PRODUCT CHANGE NOTIFICATION

Ref Nr: EBR-0176-17091301

FROM: Product Marketing, R-chip BU

This notification is to inform you that Yageo is going to rectify the temperature of solder bath for the test of soldering heat resistance and the highest temperature in our soldering file for SnAgCu solders to be 260°C.

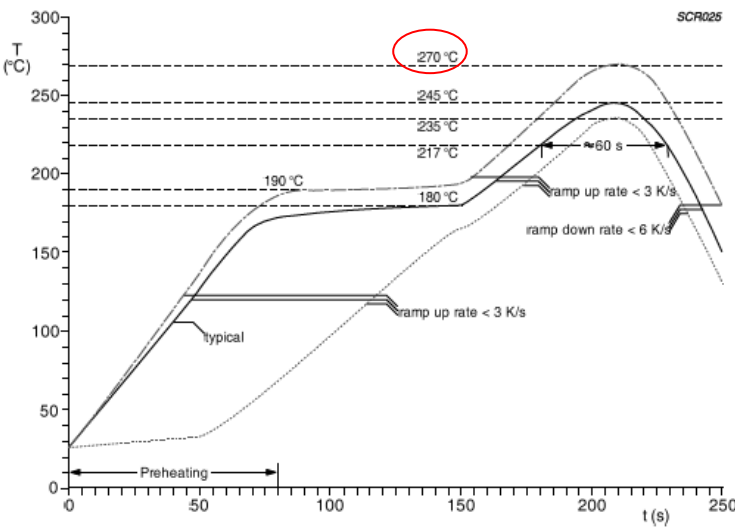
By mistake the temperature of the soldering bath for the test of soldering heat resistance and the highest temperature in soldering profile for SnAgCu solders was indicated 270°C. Based on the reference standard "MIL-STD-202G-method 210F (the original version listed in mounting datasheet is version F. Version G is an updated version after version F)" which Yageo listed in mounting datasheet, the highest temperature is 260°C. Therefore Yageo is going to rectify this typo error.

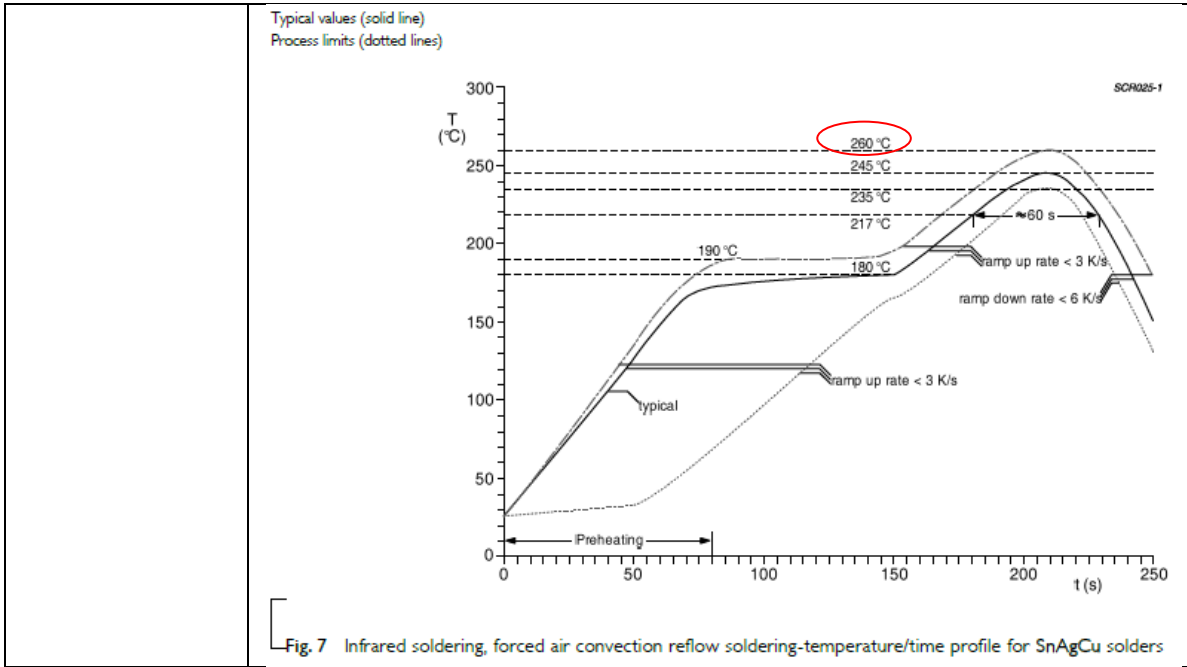
REASONS: To rectify the typo of the highest temperature in soldering profile for SnAgCu solders in mounting datasheet
